7.1 Earthworks

6.0 Section 79C(1)(b) – Likely Impacts of the Development

Figure 4: Council's assets (sewer, water and stormwater)

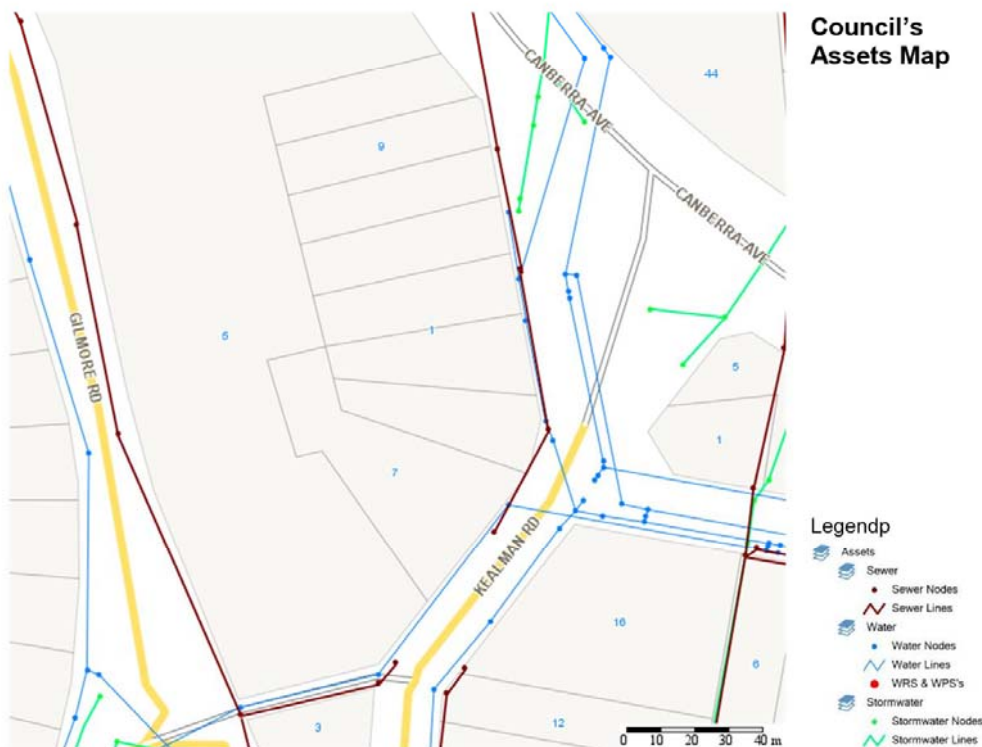
Assessment Comments - The property has sewer running adjacent to the Bowen Place boundary and should be adequate in size and location for the development to discharge. The applicant by virtue of its proposed operations will become a trade waste discharger, the mix of connections will be Concurrence C and A classifications. The Department of Primary Industries (Office of Water) will be the consent authority for the licensing of the discharge of putrescible waste wash down as this waste inherently has high levels of BOD (Biological Oxygen Demand) and COD (Chemical Oxygen Demand) that will require reduction prior to discharge to the authority's sewer network.
